**SUPPLEMENT 1
TO
BORIC ACID CONCENTRATION
REDUCTION EFFORT**

CEN-353(F)

**SAINT LUCIE NUCLEAR POWER PLANT
UNIT 1**

**PREPARED FOR
FLORIDA POWER & LIGHT COMPANY**

FIGURE 3-1 ST. LUCIE 1 MIN BMT VOLUME vs STORED BMT CONCENTRATION

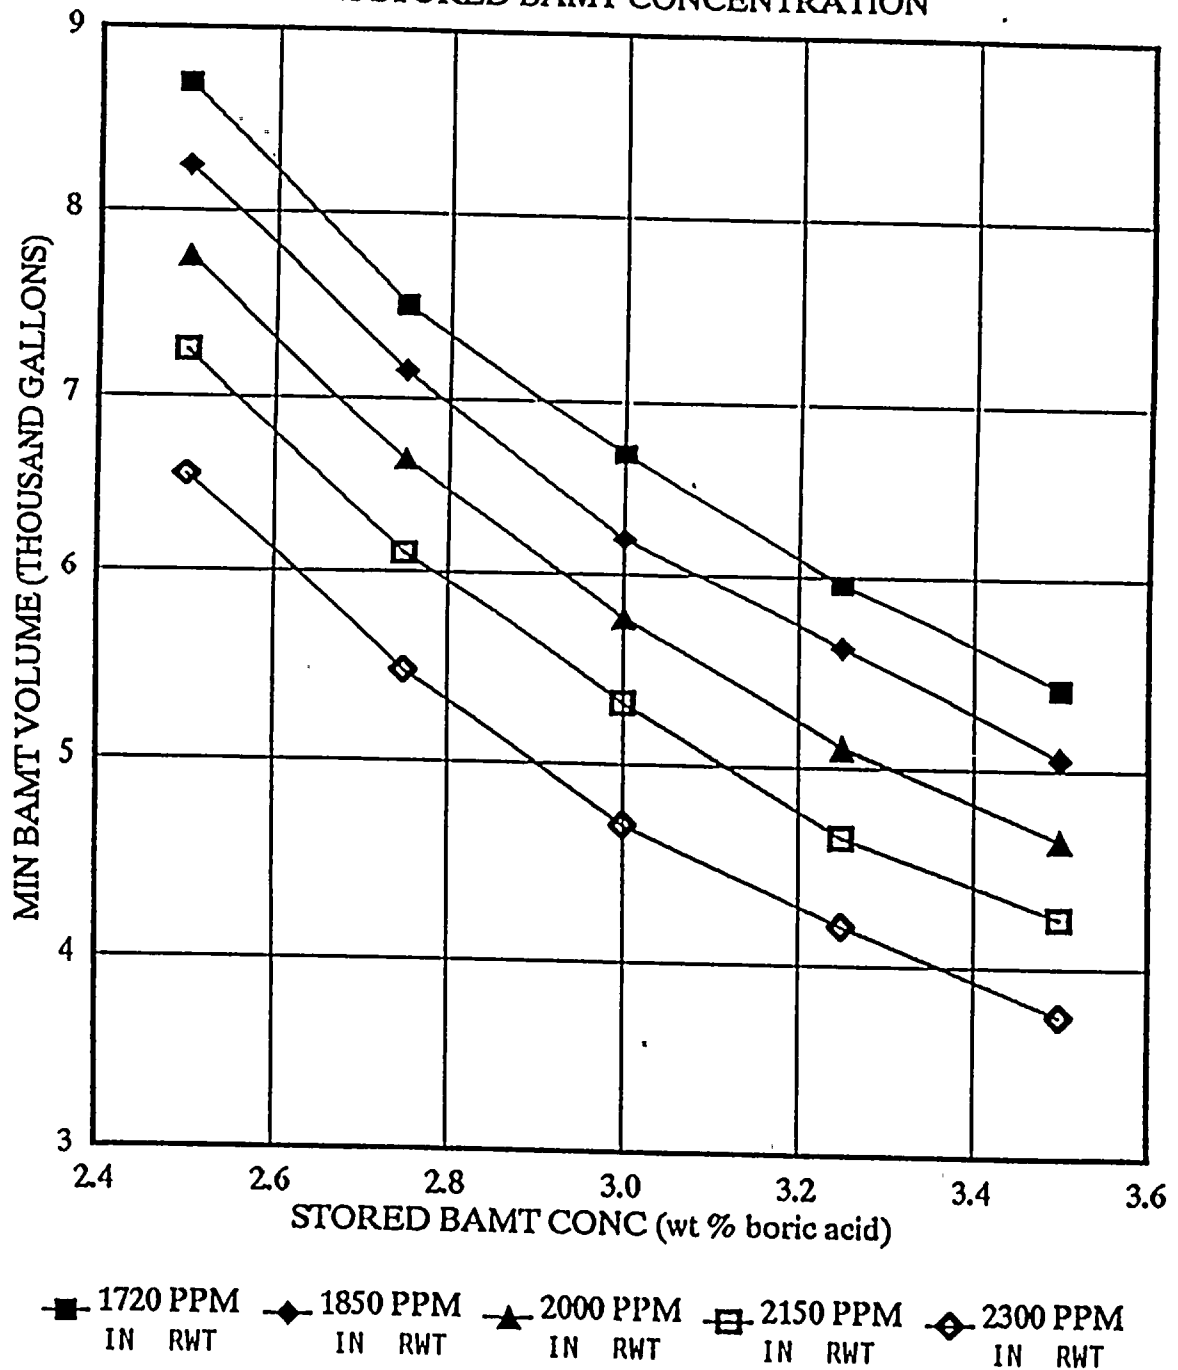
During the St. Lucie Unit 2 BACR analysis, 500 gallons were added to the BAMT boration volumes for conservatism. To be consistent with Unit 2, 500 gallons will be added to the St. Lucie Unit 1 BAMT boration volumes to define the revised Technical Specification BAMT Storage volume requirements. The boration volumes will be rounded up to the next 50 gallons, and 500 gallons will be added for conservatism. The resulting Required BAMT Storage Volumes are contained in Table 3-2 and are plotted in Figure 3-1. Figure 3-1 provides the revised storage requirements to replace Figure 2-6 on page 82 of the main report.

FP&L currently requests that only one curve be presented in the Required BAMT Volume curve, Technical Specification Figure 3.1-1, rather than the family of curves for various RWT concentrations. FP&L requests that only the curve for the RWT at 1720 ppm be provided. The new Technical Specification Figure 3.1-1 is contained in Appendix A.

BAMT at wt %	RWT at 1720 ppm	RWT at 1850 ppm	RWT at 2000 ppm	RWT at 2150 ppm	RWST at 2300 ppm
2.50	8700	8250	7750	7250	6550
2.75	7500	7150	6650	6100	5450
3.00	6700	6200	5750	5300	4700
3.25	5950	5600	5100	4650	4200
3.50	5400	5050	4650	4250	3750

FIGURE 3.1-1 ST. LUCIE 1 MIN BAMT VOLUME

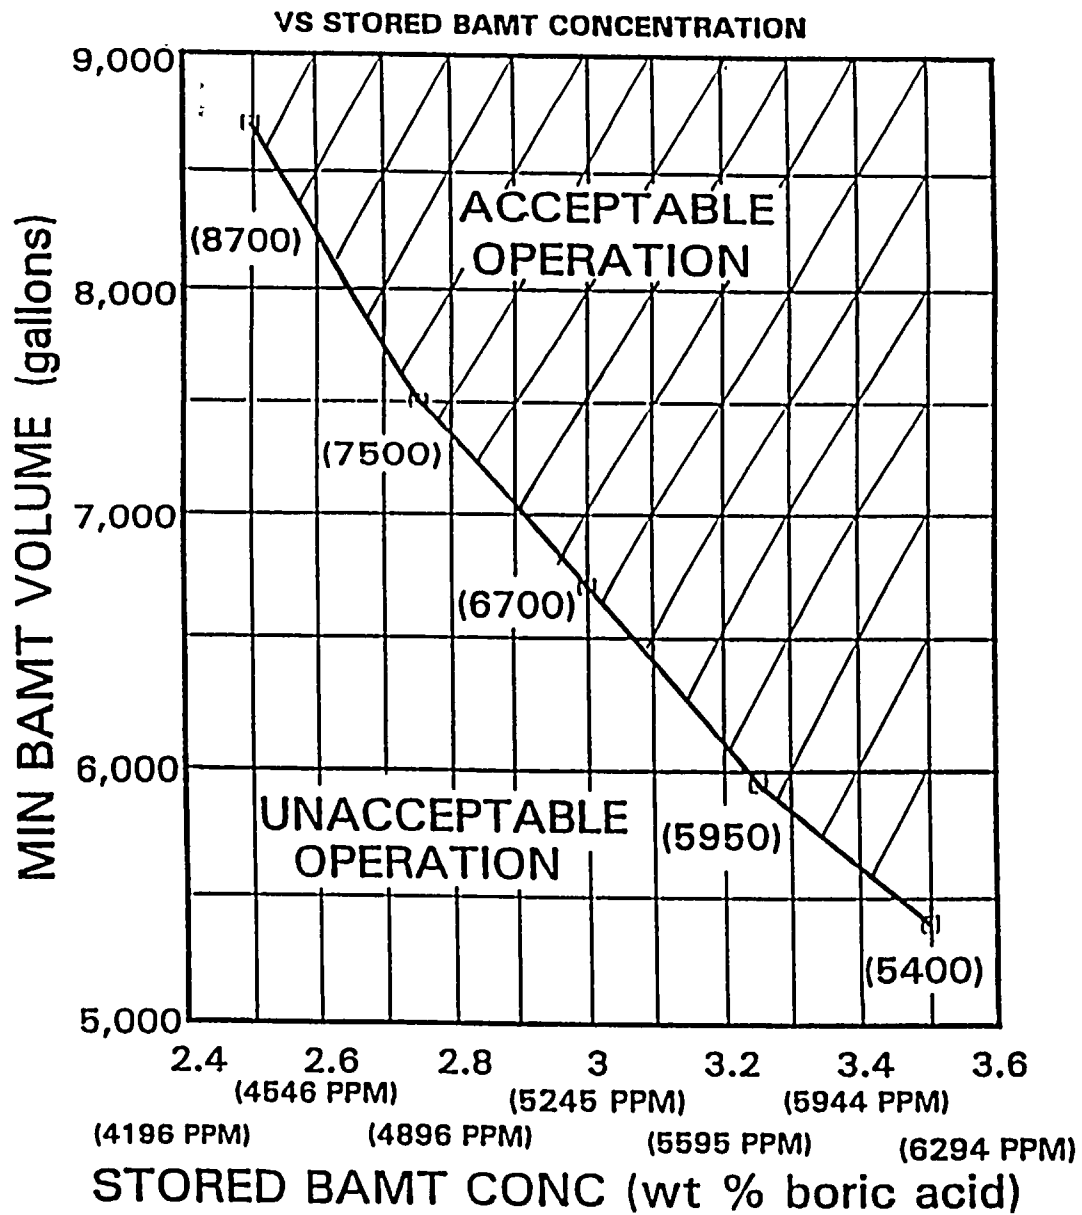
- a. Boric Acid Makeup Tank 1A in accordance with Figure 3.1-1, ~~and in the range of 3.2 to 3.5 weight percent boric acid (5595 to 6119 ppm boron).~~
- b. Boric Acid Makeup Tank 1B in accordance with Figure 3.1-1, ~~and in the range of 3.2 to 3.5 weight percent boric acid (5595 to 6119 ppm boron).~~
- c. Boric Acid Makeup Tanks 1A and 1B with a minimum combined contained borated water volume in accordance with Figure 3.1-1.
- d. The refueling water tank with:
 1. A minimum contained volume of 401,800 gallons of water,
 2. A minimum boron concentration of 1720 ppm,
 3. A maximum solution temperature of 100°F,
 4. A minimum solution temperature of 55°F when in MODES 1 and 2, and
 5. A minimum solution temperature of 40°F when in MODES 3 and 4.
